Device	XC164CS-8F
Marking/Step	(E)ES-BB, BB
Package	PG-TQFP-100-5, P-TQFP-100-16

This Errata Sheet describes the deviations from the current user documentation.

1 History List/Change Summary

Figure 1 Example for Case 2: Interrupt Service for Task C delayed

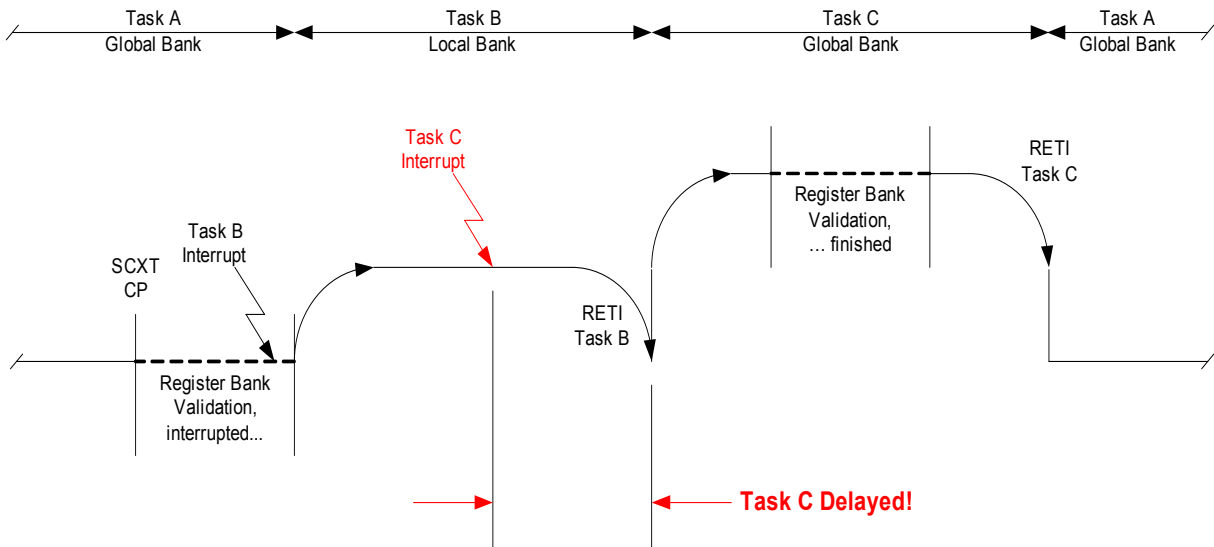
Case 2 (see also Figure 1):

- The Context Pointer CP is written to (e.g. by POP, MOV, SCXT .. instructions) within a routine (Task A) that uses a **global** register bank (bit field PSW.BANK = 00_B), i.e. the context for this routine will be modified,
- This context switch procedure (19 cycles) is interrupted by an interrupt request (Task B) which is programmed (with GPRSELx = 1X_B) to automatically use one of the **local** banks via the bank selection registers BNKSEL0..3 (i.e. the interrupting routine has a priority level ≥ 12),
- Before the corresponding interrupt service routine is finished, another interrupt request (Task C) occurs which is programmed (with GPRSELx = 00_B) to automatically use the **global** bank via the bank selection registers BNKSEL0..3 (i.e. the interrupting routine has a priority level ≥ 13)

In this case service of this interrupt request (for Task C) is delayed until bit field PSW.BANK becomes 00_B after executing the RETI instruction at the end of the routine (Task B) using the local bank.

Workaround for Case 2

When using both local and global register banks via the bank selection registers BNKSEL0..3 for interrupts on levels ≥ 12 , ensure that there is no interrupt using a global register bank that has a higher priority than an interrupt using a local register bank.
